Identity of Attestation

RE : Identity between the Models **FA-W6100 & ACC-W6100** and **FA-W5100 & ACC-W5100**.

Picture 1

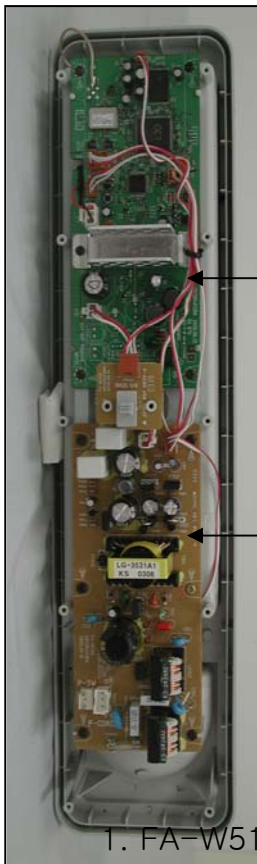
- Model name is changed.
- Antenna and connectors of main PCB were changed as shown at picture1 of attached .
- SMPS (Power supplier) Board is modified as shown at picture 2 and circuit diagram.
- Enclosure is modified as shown at picture 2 of attached

Only connector type is changed and pin assignment is same

Passive Speaker Connector Is removed
